MATANUSKA-SUSITNA BOROUGH PLATTING BOARD AGENDA

**APRIL 1, 2021
REGULAR MEETING
1:00 P.M.**

PRELIMINARY PLAT: **STELLA RIDGE MASTER PLAN**
LEGAL DESCRIPTION: **SEC 18, T18N, R1E, SEWARD MERIDIAN, AK**
PETITIONER: **JERRY HARMAN**
SURVEYOR/ENGINEER: **HANSON LAND SOLUTIONS**
ACRES: 60.0 PARCELS: 51
REVIEWED BY: CHERYL SCOTT CASE: 2020-098

EXHIBIT D

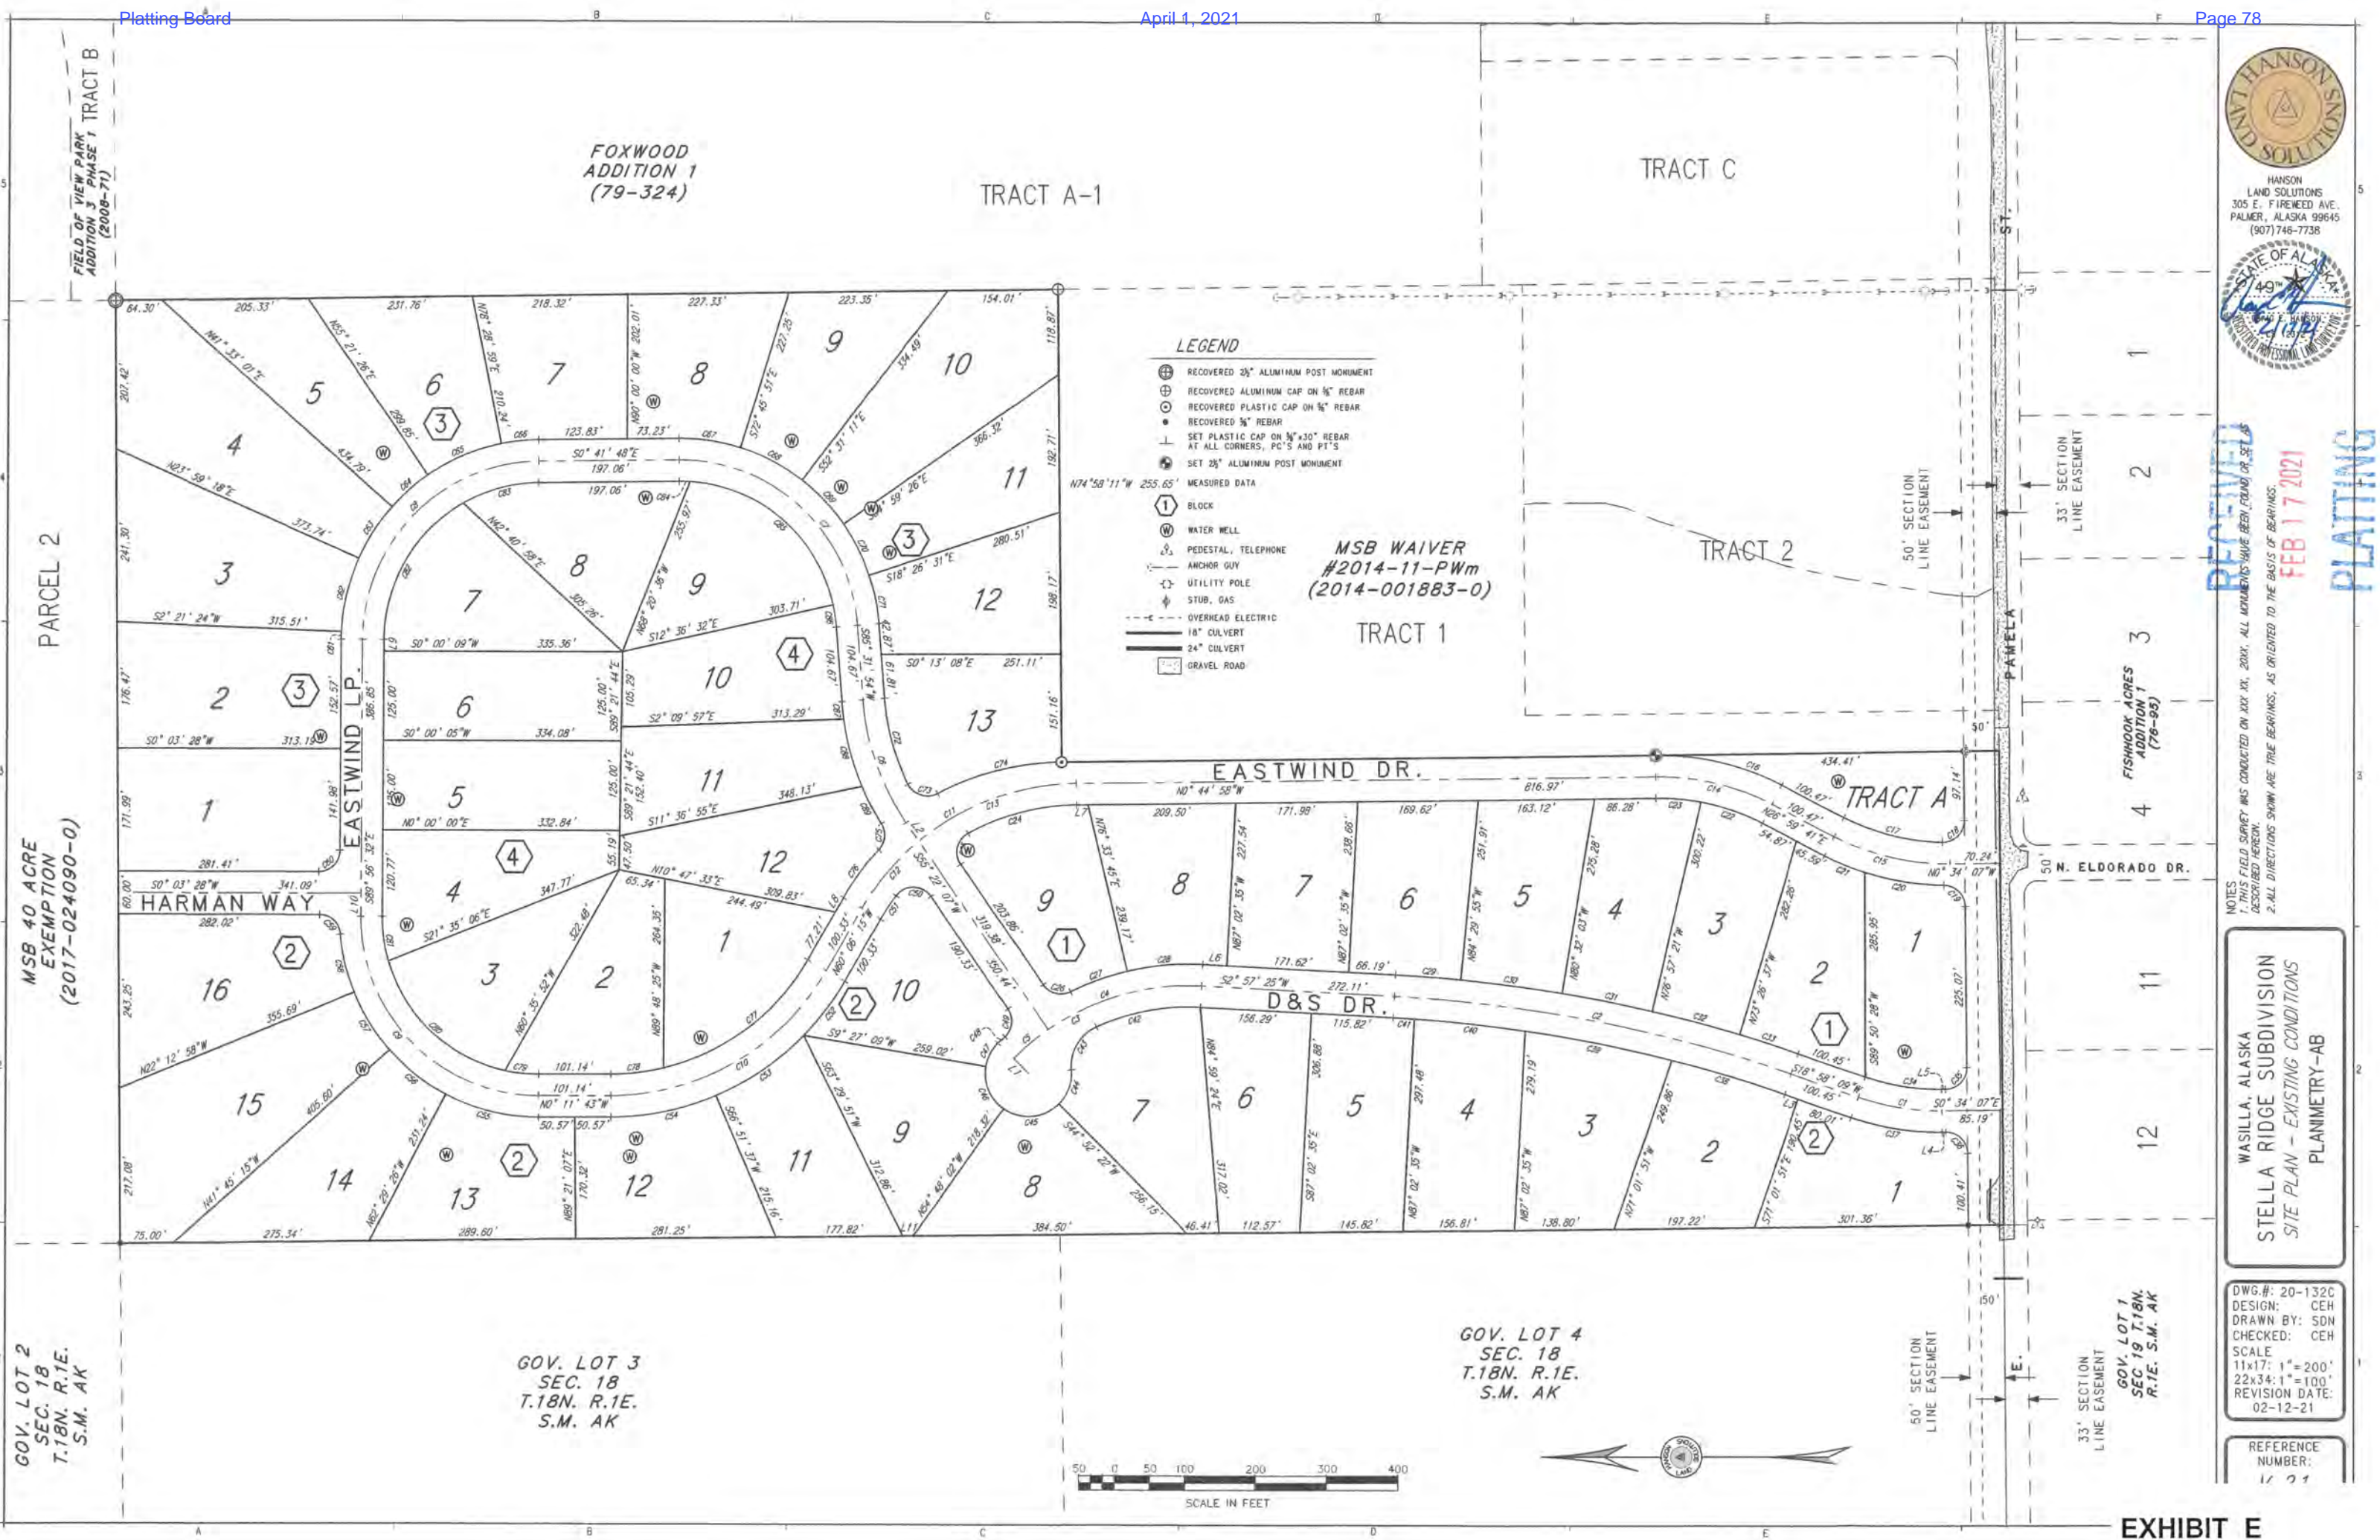
Drainage: Hanson Land Solutions provided a drainage plan, meeting the Subdivision Construction Manual standards **(Exhibit G)**. The drainage plan shows the drainage along the proposed roads and general drainage patterns within and directly adjacent to the subdivision. The plan also shows proposed culverts and infiltration points. The drainage plan is subject to field modification and improvement during the road construction work.

- b. Provide verification of roadways per MSB 43.20.140(A)(2)(a) & (b).
 - c. Provide DPW acceptance of the roads to Platting staff.
 - d. Address DPW's comments on Drainage Plan and submit updated drainage plan if needed.

WASILLA, ALASKA
STELLA RIDGE SUBDIVISION
PLAN AND PROFILE - DESIGN
E. PAMELA DRIVE

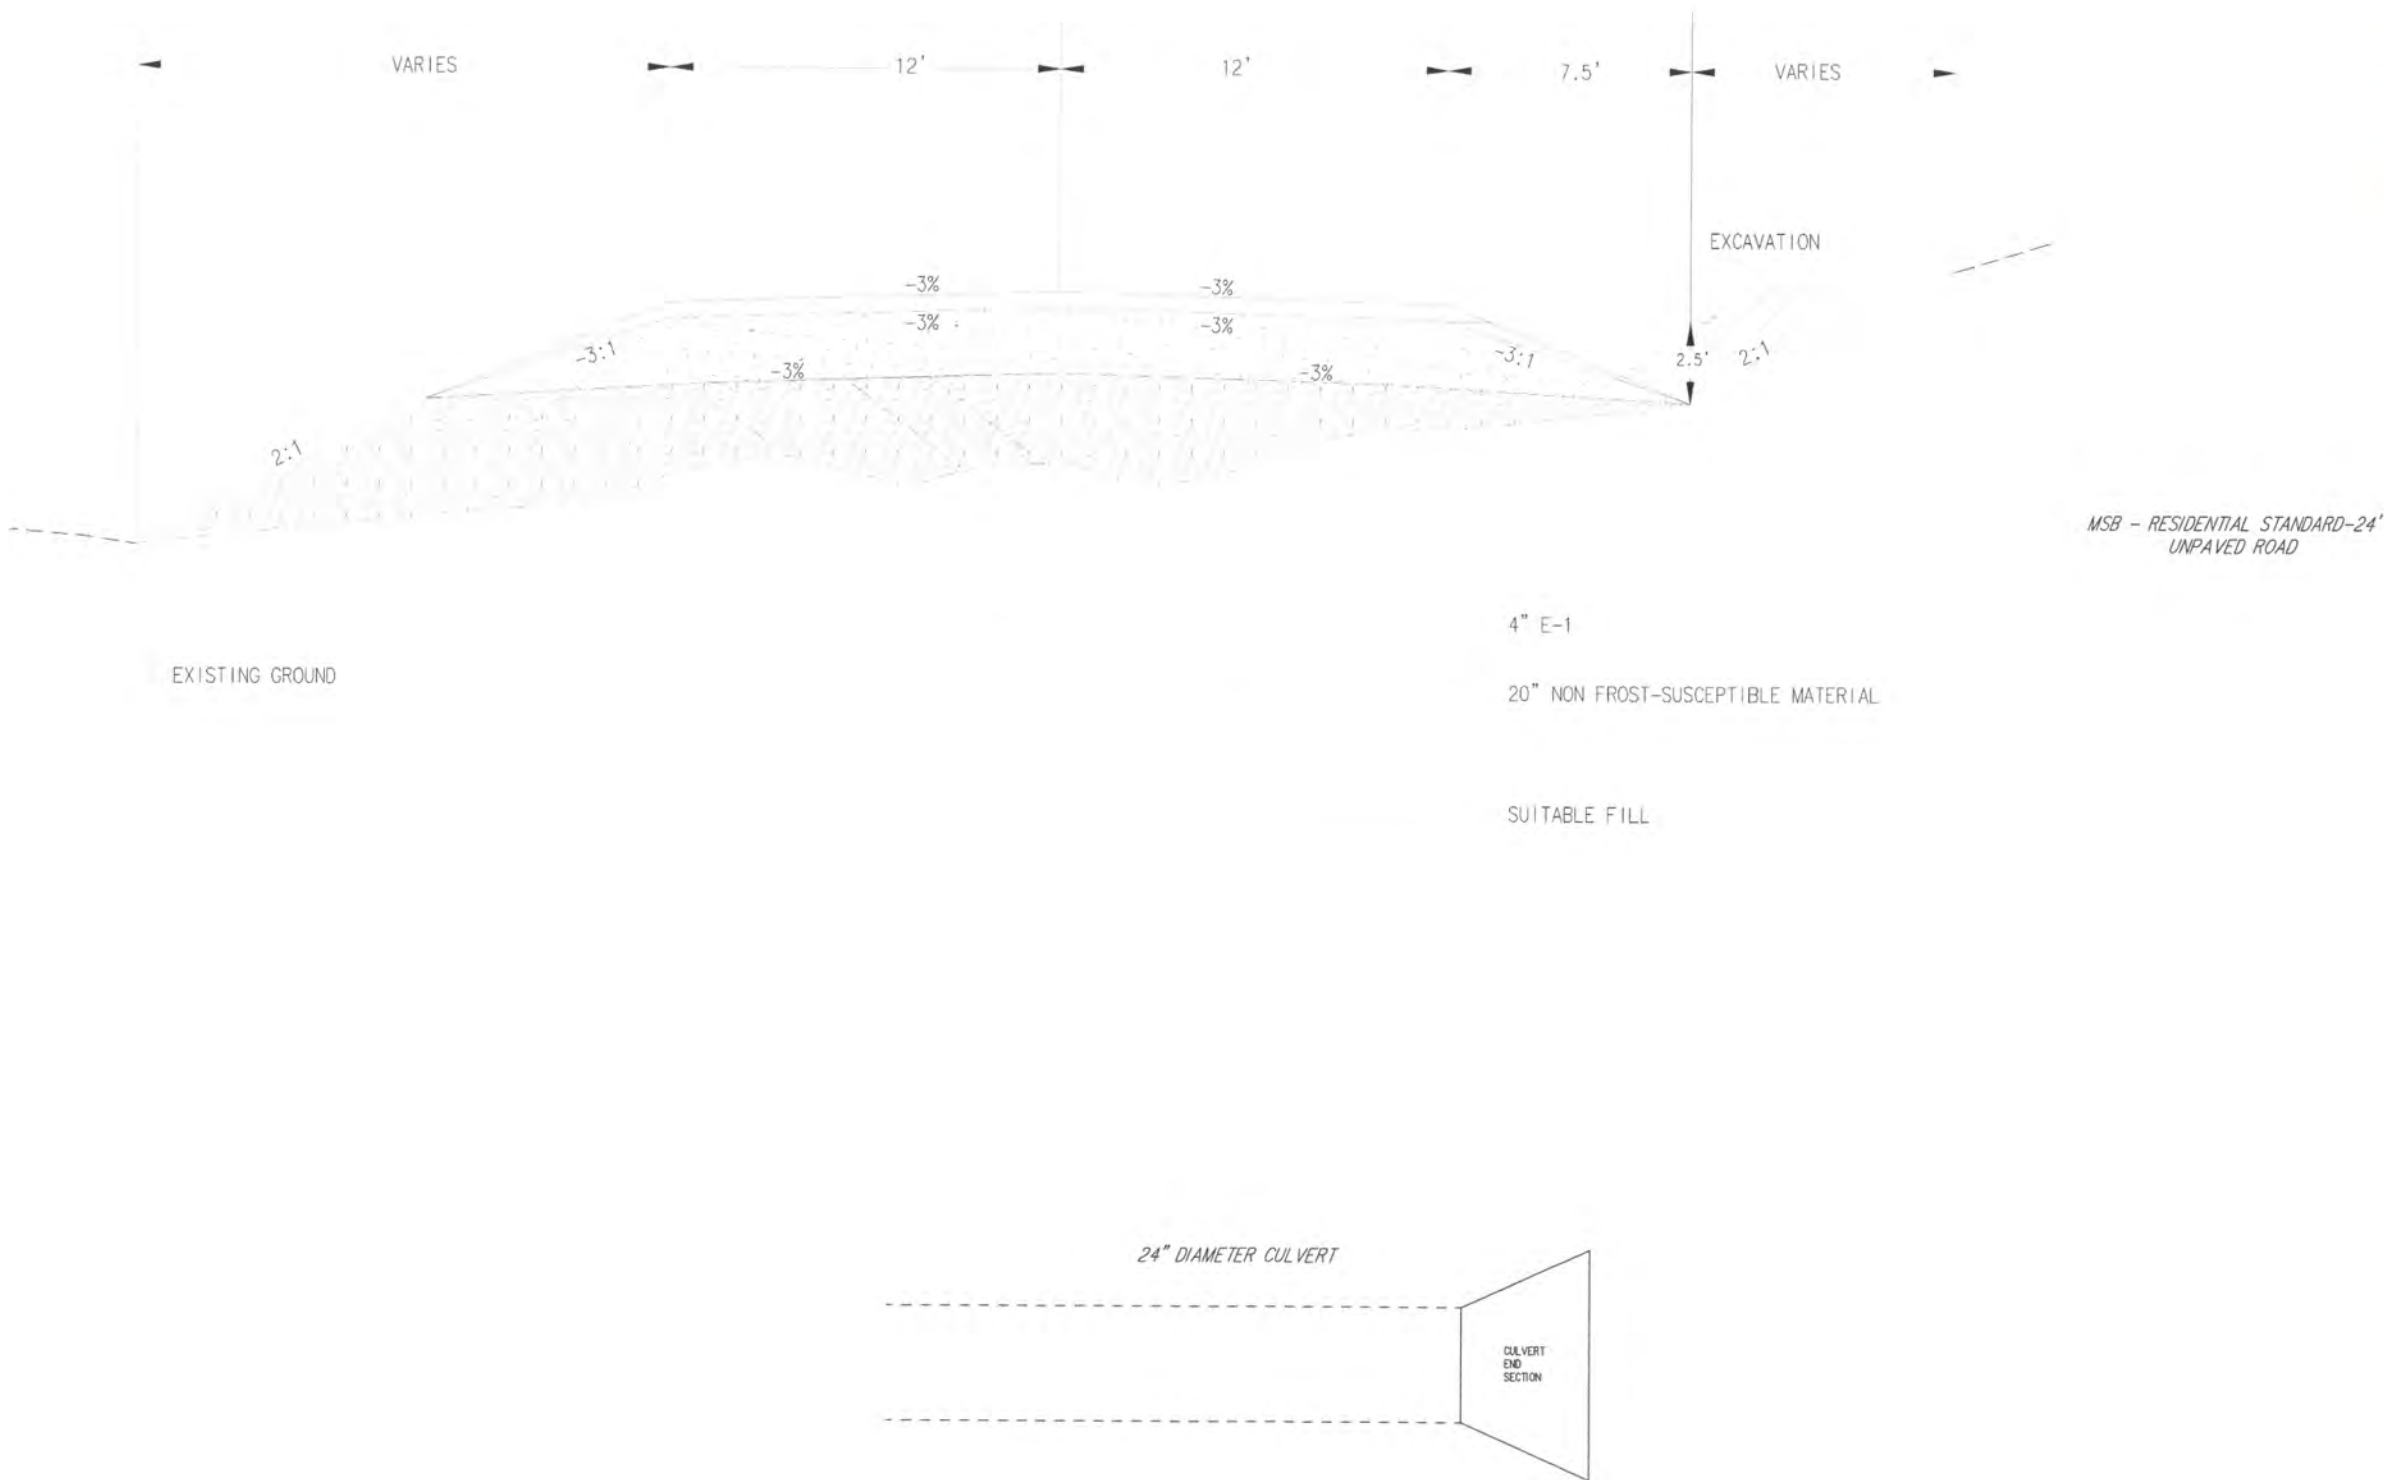
- Certify or upgrade Pamela Drive to Residential Collector standard from Eldorado to proposed D&S Drive
- Remove existing driveway on Pamela
- Drainage Plan: Place cross culverts outside of curve returns – requires less culvert and reduces likelihood of culvert ends being crushed, only need 2 cross culverts at 4-way intersection, may need drainage easements

7. Show a 60' radius temporary cul-de-sac on Harman Way on the final plat.
8. Construct D & S Drive, Eastwind Drive, Eastwind Lane and Eastwind Loop to residential standards unless otherwise determined. Upgrade or certify Pamela Drive to Residential Collector standard from Eldorado Drive to D&S Drive unless otherwise determined:

EXHIBIT J

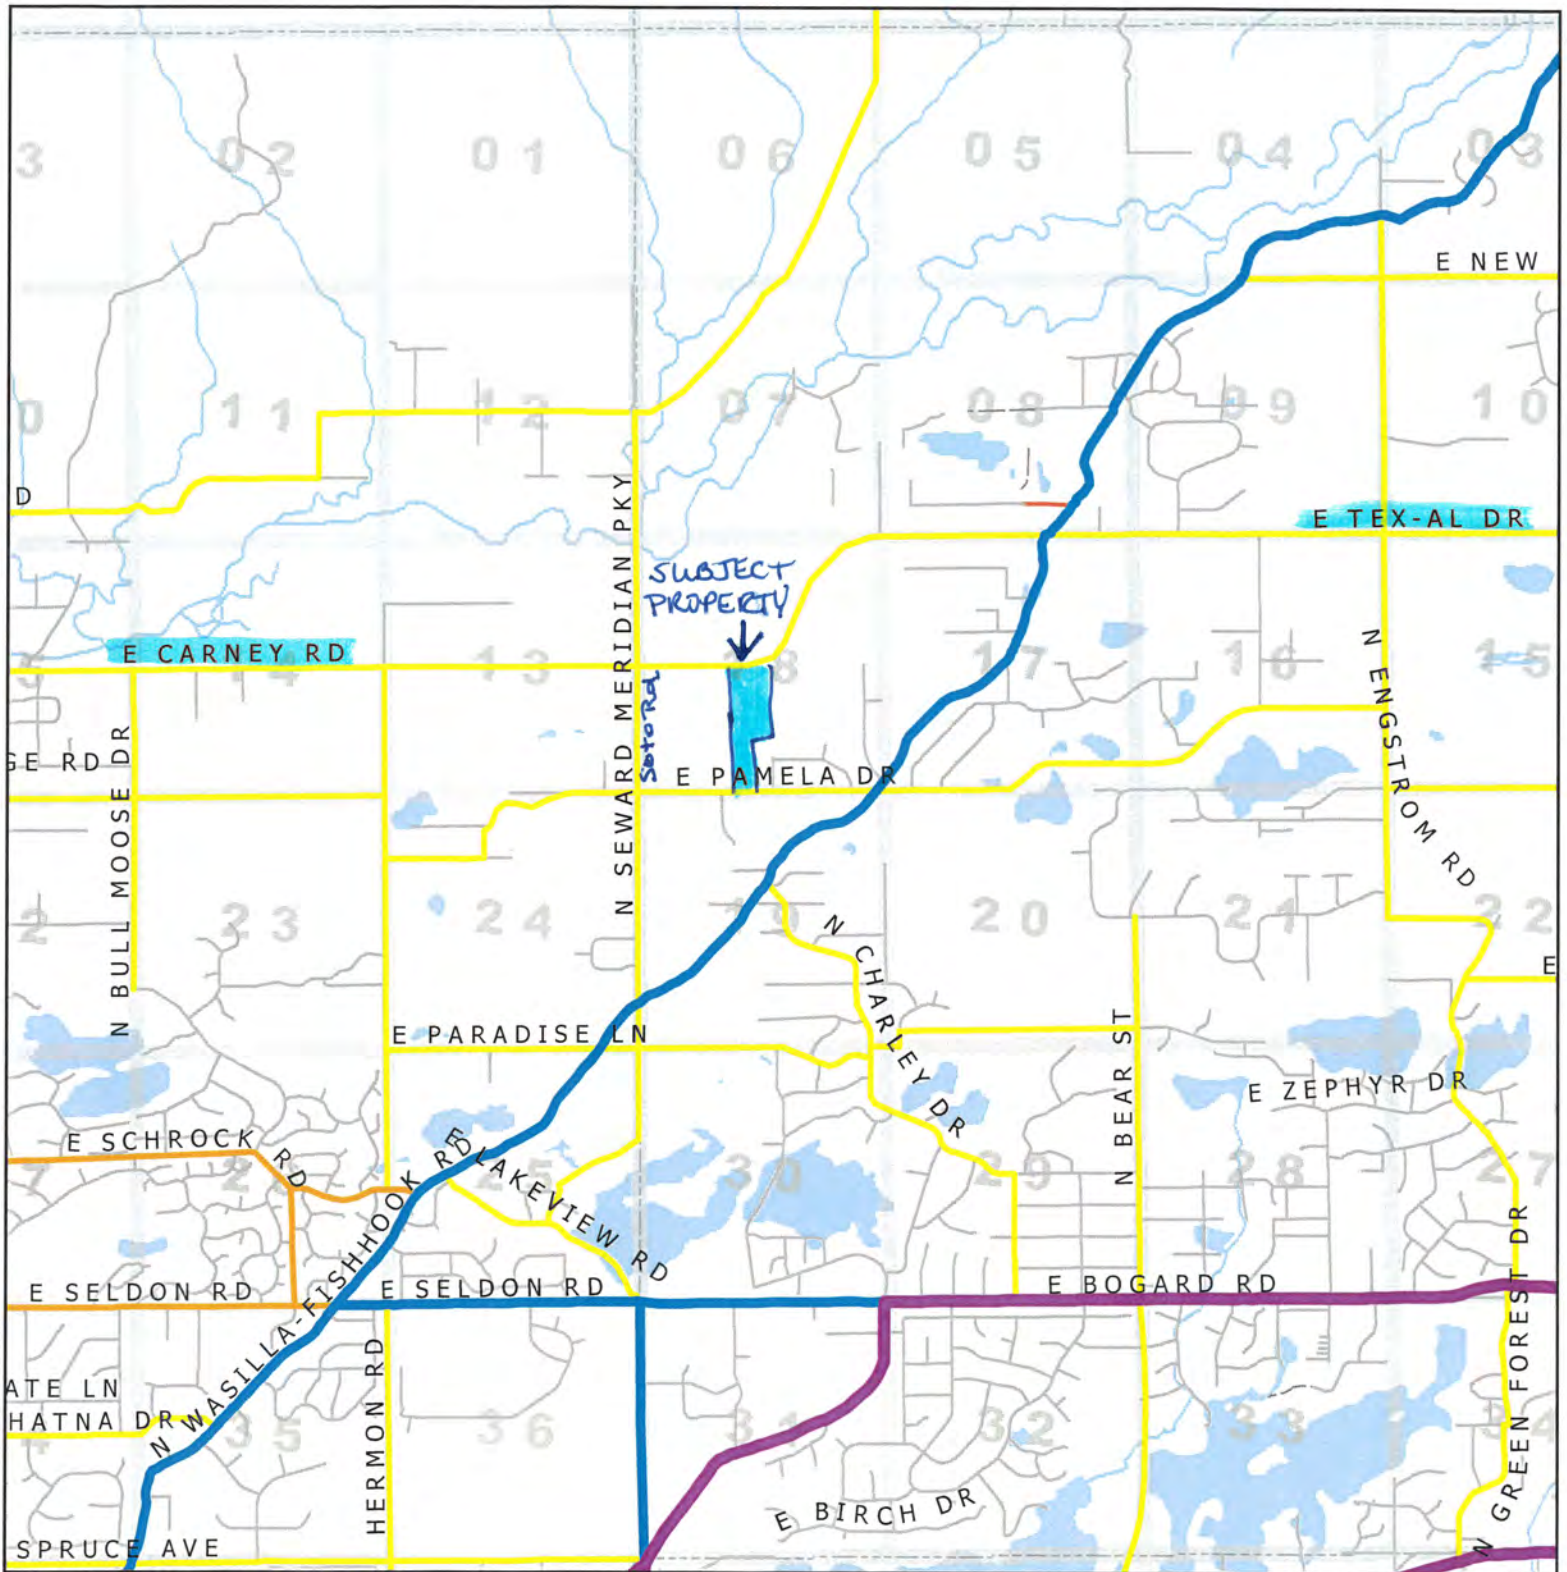
The applicant provided a stub right-of-way (ROW) to connect to a future minor collector, East Carney Road identified in the OSHP. Planning would encourage the applicant to also provide a stub ROW to the undeveloped parcels to the east and west of Stella ridge to support future road network connectivity.

Planning requested a 30' ROW or a 25' setback be added due to the Carney Road connection on the OSHP. The petitioner provided a 25' setback on the preliminary plat; we have no objections with the setback.
